11 May 2026

**Re. SSD-65490715 Central Park Bradfield City Centre - Post Approval Document Submission
Condition C42 – Wayfinding Plan**

The purpose of this submission is to obtain the endorsement from the Planning Secretary on the provided Wayfinding Plans for the development.

01_SIGNAGE AND WAYFINDING

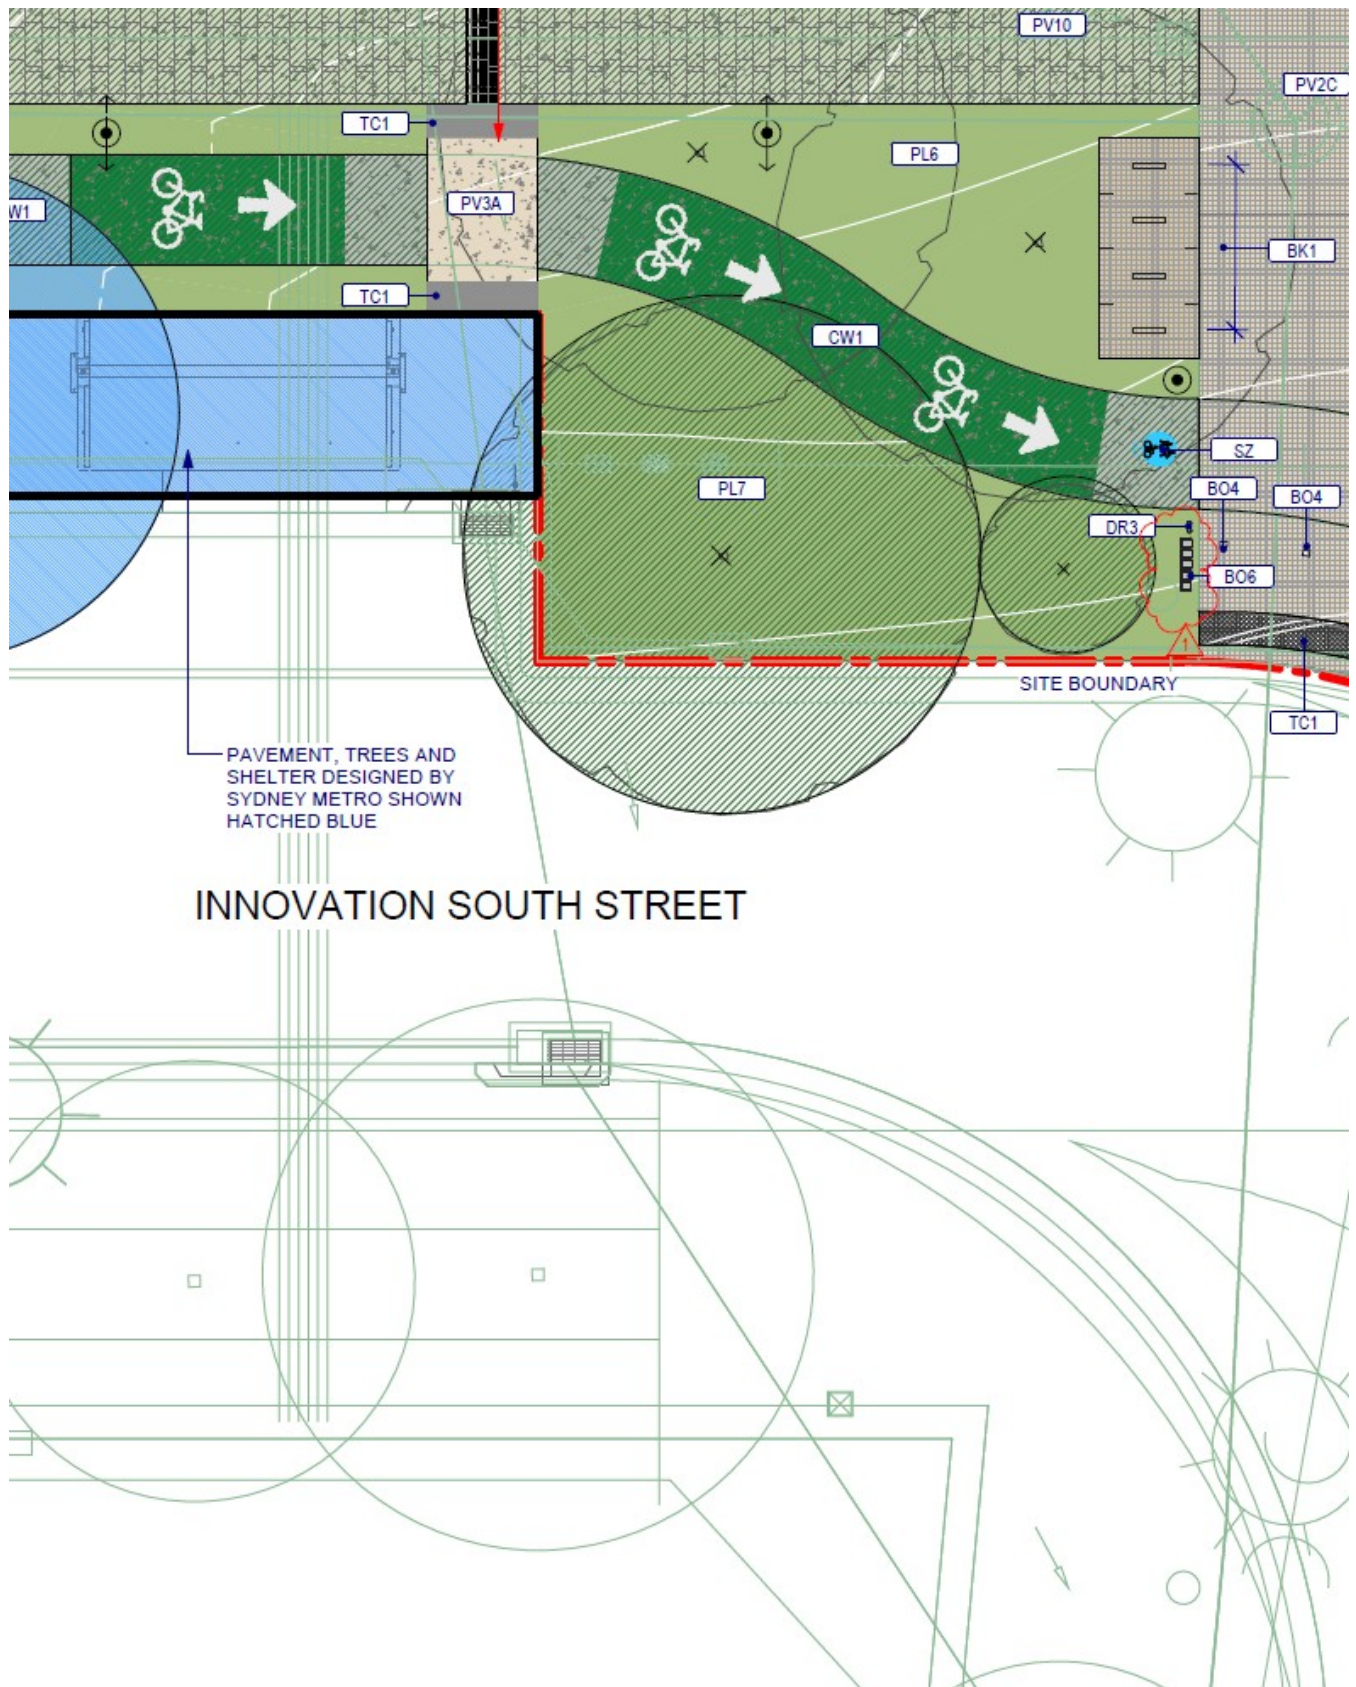
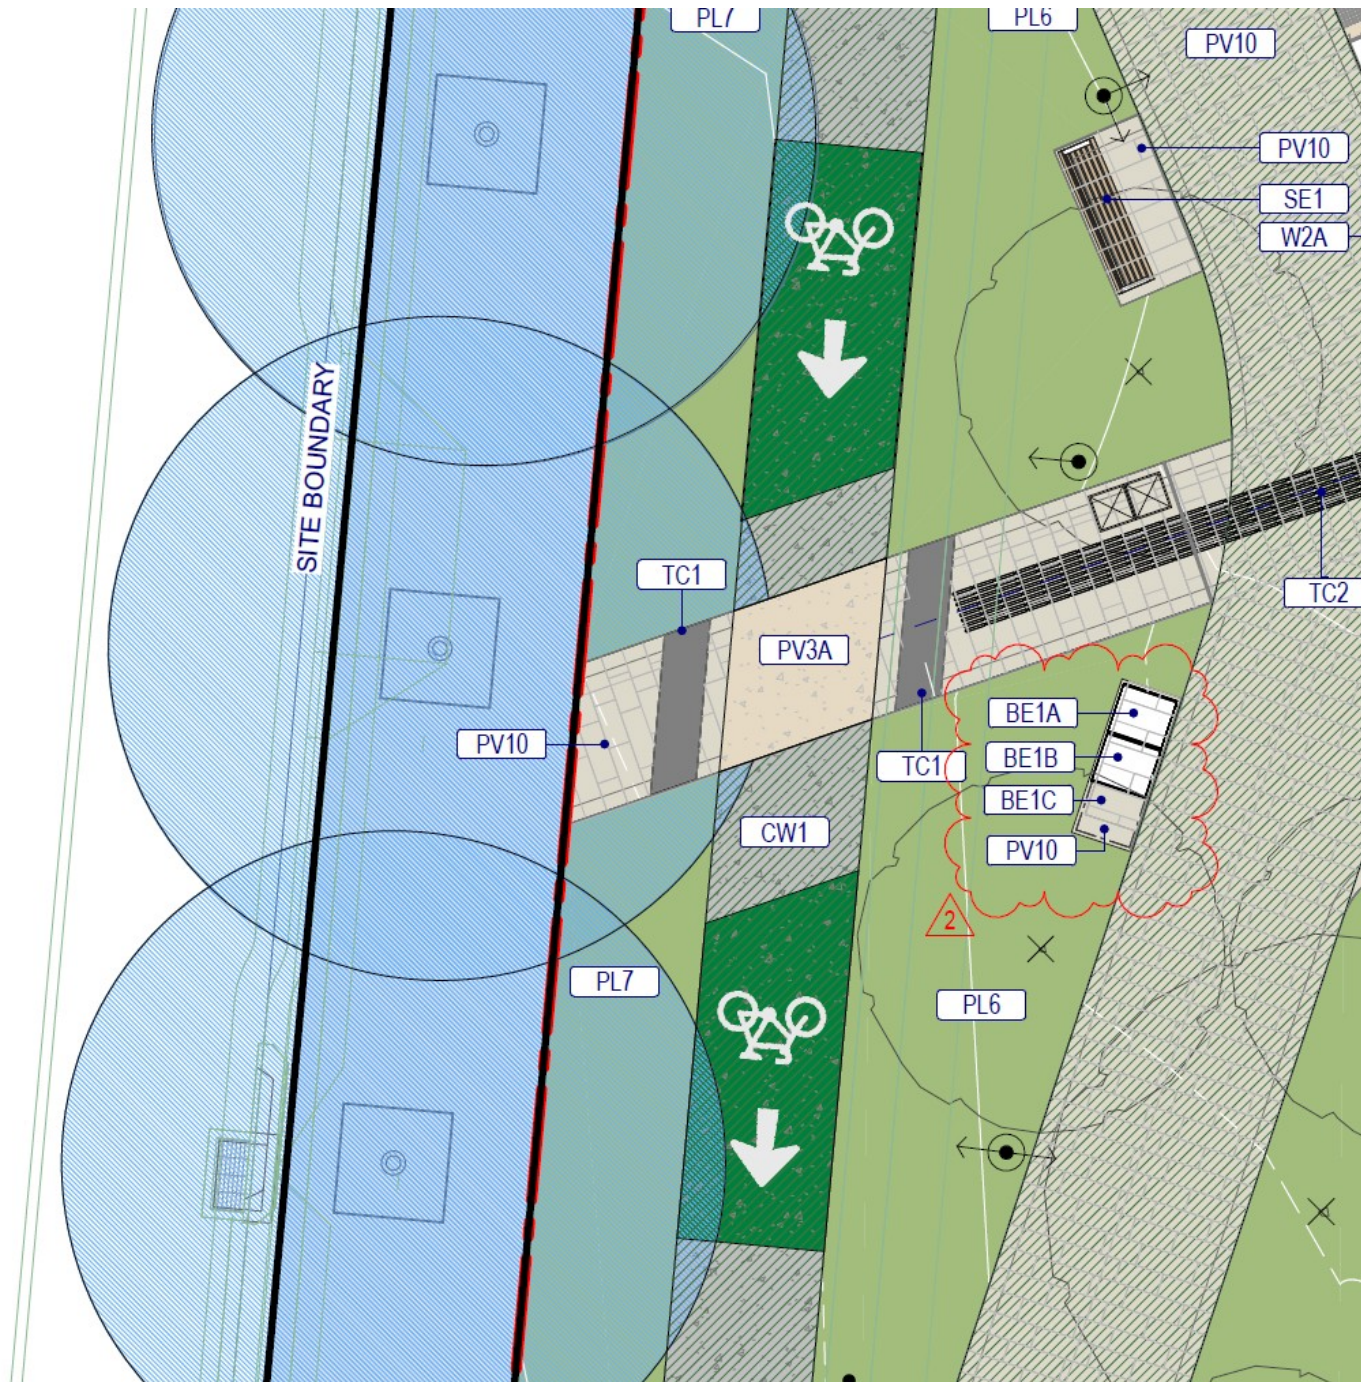
- (1) In relation condition C42., which requires the wayfinding plan to address how the signage would not contribute to visual clutter, the current package does not provide sufficient information to review this. Further information such as detailed plans are recommended to clearly demonstrate the exact scale and placement of the proposed signage and to ensure they are appropriately positioned to maximise legibility and accessibility, particularly where signs are dual-facing and/or located within garden beds, circulation networks or in proximity to other elements in the landscape. This will also assist in ensuring that the signage does not visually or physically obstruct movement throughout the park. Visual renders could also

be explored to help demonstrate the relationship between the signage and the landscape, which is not currently evident in the signage allocation plan. Refer to the render example below as previously issued.

- The Wayfinding Strategy outlines a coordinated approach to the placement of signage throughout Central Park, guided by key decision points along visitor journeys. The number of signs has been minimised to reduce visual clutter, with each sign positioned strategically to support circulation. The scale of the signage suite has been developed in response to both the information hierarchy and the hierarchy of landscape paths. Legibility has been considered and optimised, with letter sizing and layout designed to ensure clear visibility from appropriate viewing distances. Please refer to the attached information illustrating the proposed signage locations within the public realm.

- Refer to Landscape GA plans for zoomed in locations (attached)
 - Refer to typical detail for sign in planting (attached)
- (2) Condition C42. requires the detailed wayfinding plan to address how the signage designs would complement the style of the public domain signage in the area. As part of this review, Council were unable to locate any relevant signage designs or guidelines for the broader public domain signage and therefore were unable to appropriately assess this aspect of the condition. The proposed signage design for Central Park demonstrates a timeless high-quality design which is specific to its park setting. Whilst Council support the idea of the signage for Central Park having its own unique identity, it is encouraged that, where possible, the overall design language of the park signage is carried through to the surrounding public domain to ensure a consistent and cohesive wayfinding experience throughout the Bradfield City Centre.
